ADDENDUM NO. 1

To: All Plan Holders of Record and Interested Parties
City of Galena, Illinois
Project: East Side Utility System Improvements
IIW Project No.: 17054
Issue Date: March 12, 2020

**WATER MAIN & SANITARY SEWER
 PLAN & PROFILE**
 CITY OF GALENA
 EAST SIDE UTILITY
 SYSTEM IMPROVEMENTS

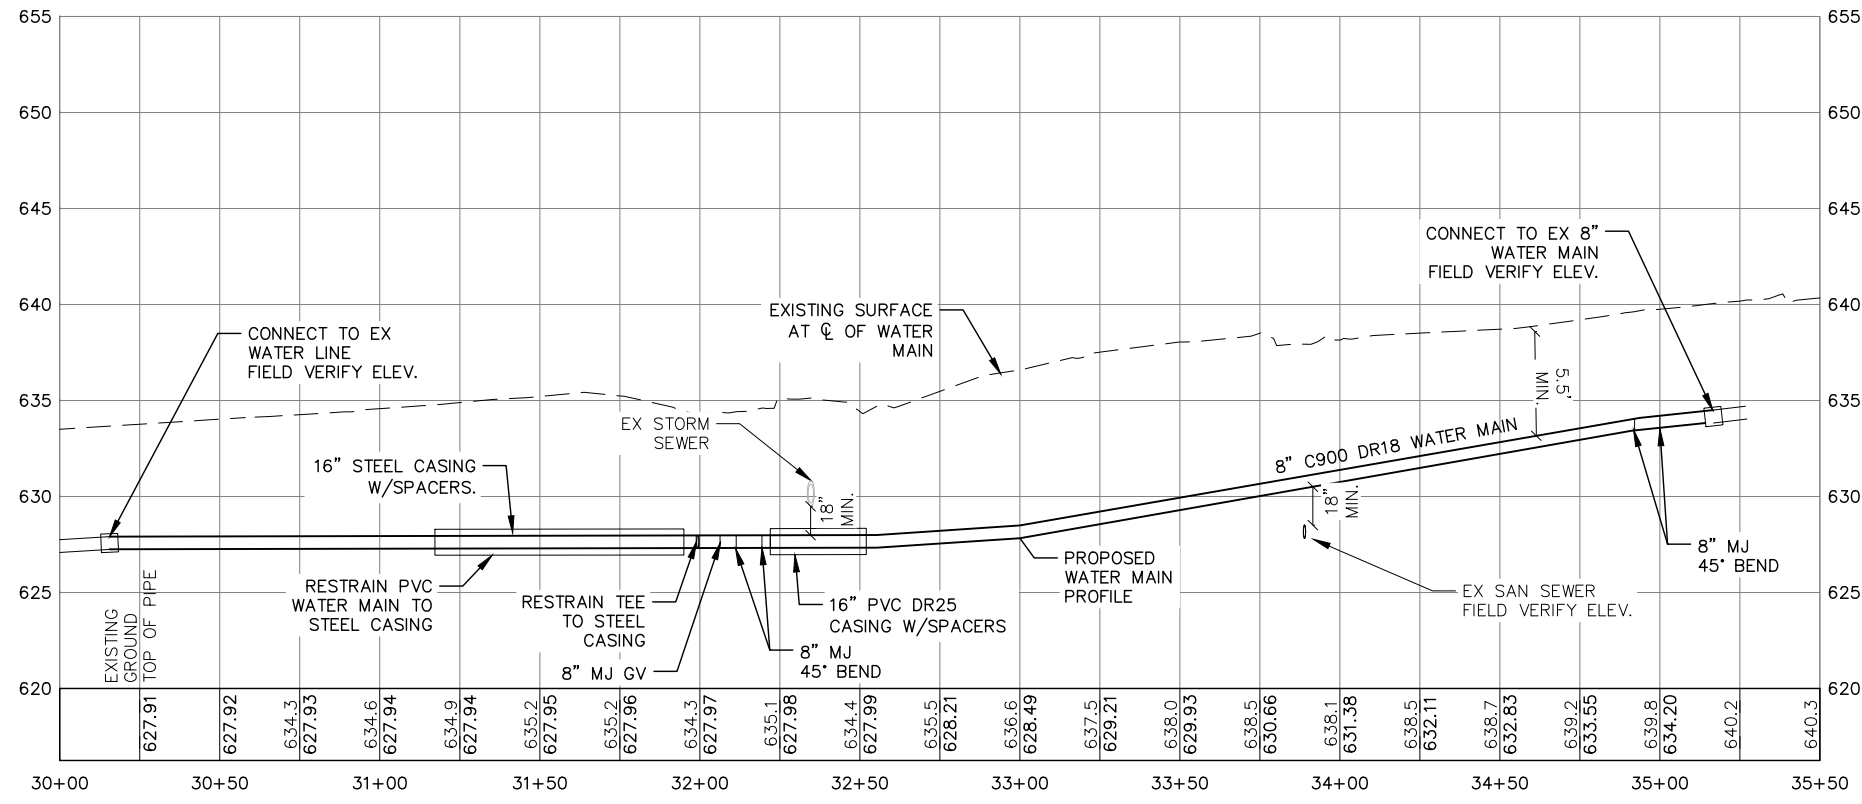
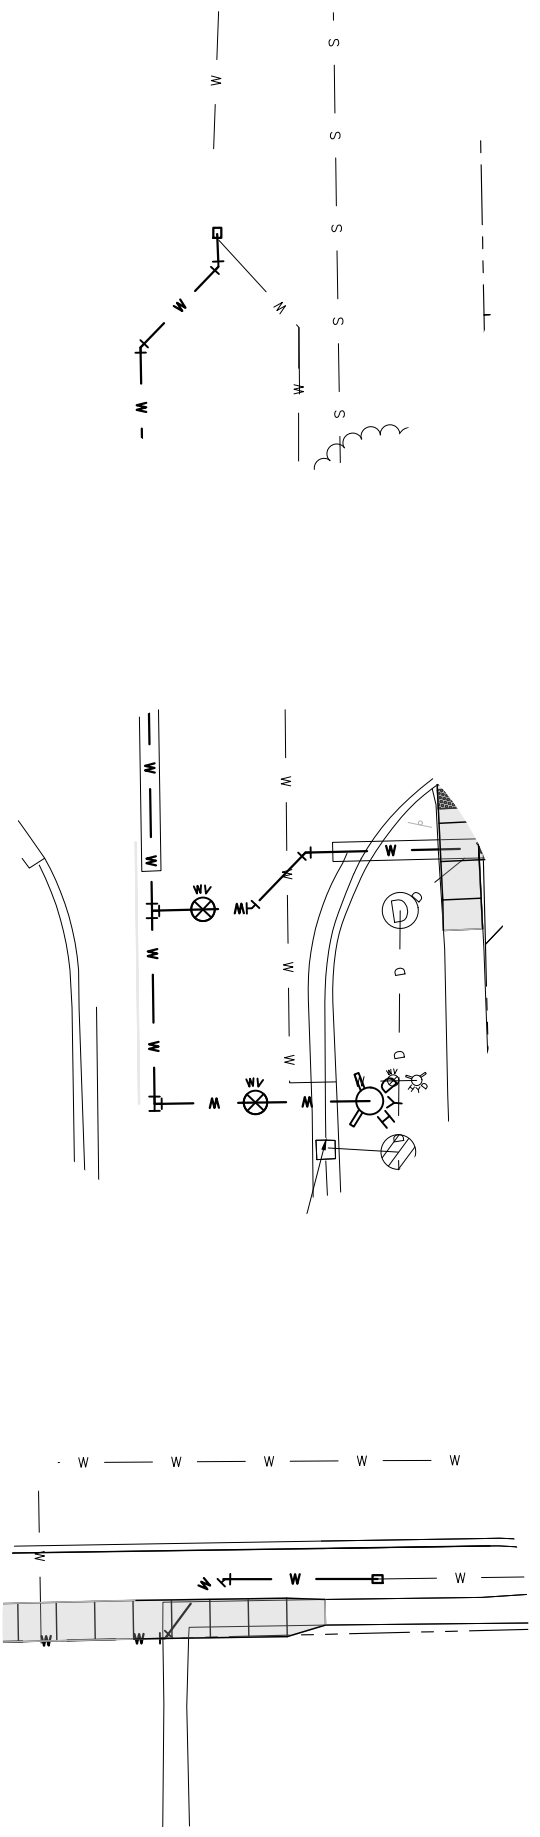
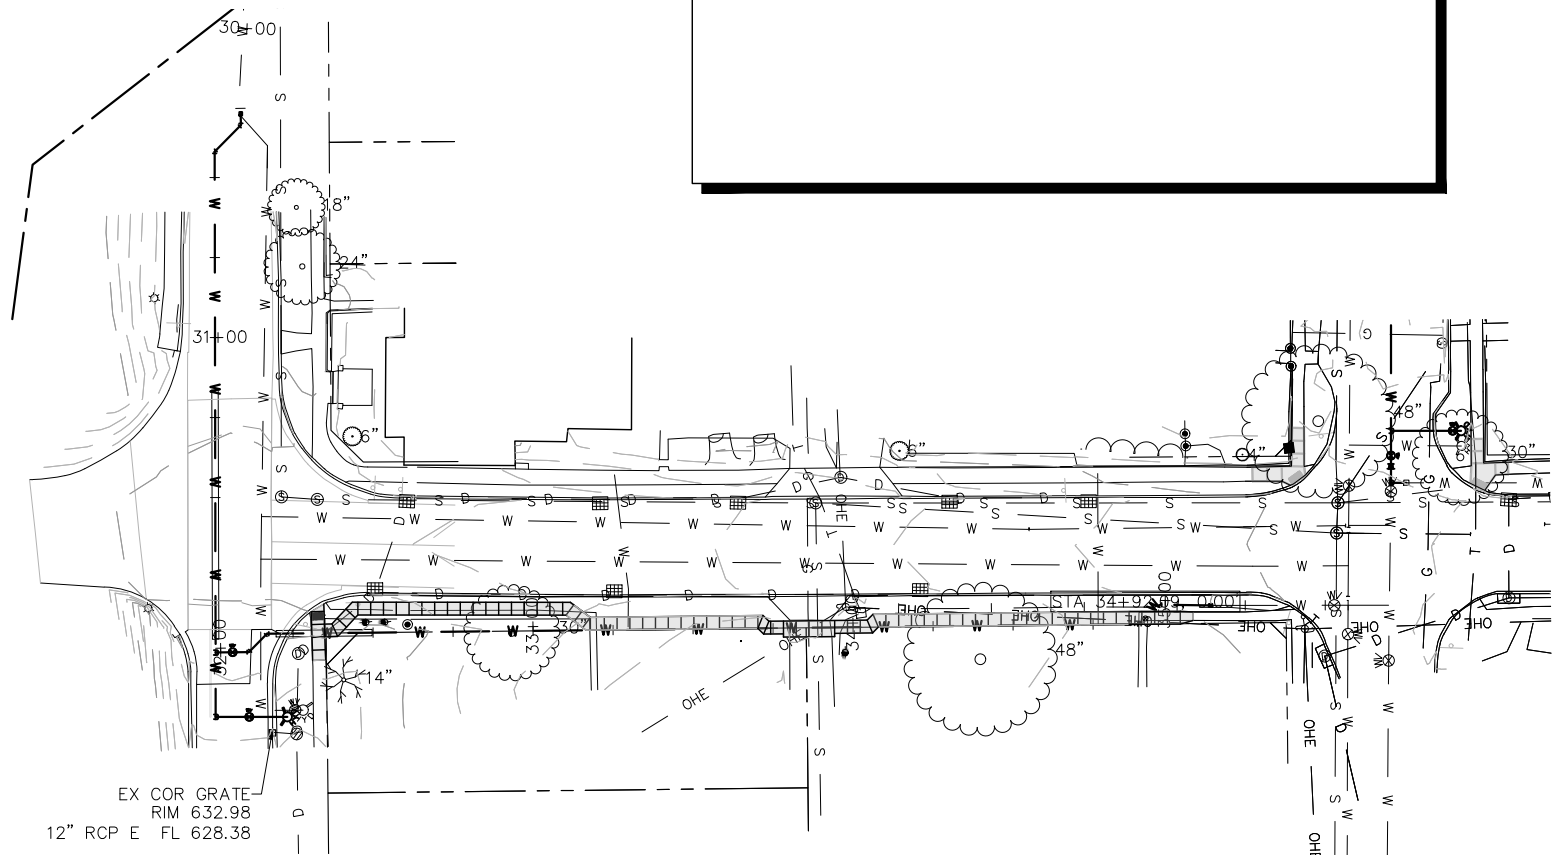
1. Sheet C5.01: Added water main notes that describe the horizontal and vertical separation between water mains and sewers.
2. Sheet C5.10: The water main alignment and vertical profile from Station 2+25 to 3+40 along Park Avenue was modified and the casing was lengthened. The water main connection at the intersection of Park Avenue and Johnson Street was also modified to meet the horizontal sewer separation requirements of the Illinois EPA.

3. Sheet C5.11: Twenty-three (23) feet of 20-in. PVC DR 25 casing was added to the project to comply with the Illinois EPA vertical separation requirements when the water main crosses beneath a sewer.

4. Sheet C5.12: A profile of the 6-in. water main on Madison Street was added to the plan sheet to indicate the vertical separation requirements when the water main crosses beneath the existing sewer.

5. Sheet C5.15: The location of existing storm sewer at Station 32+35 shown in the profile was moved to depict the correct location of the storm sewer crossing.

9
C6.01 **TYPICAL SIDEWALK**
NOT TO SCALE

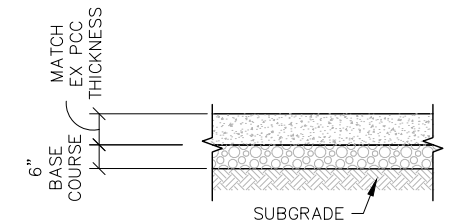
6. Sheet C6.01: The typical sidewalk detail was updated. The PCC sidewalk thickness changed from 4" to 5". The PCC driveway thickness changed from 6" to 7".
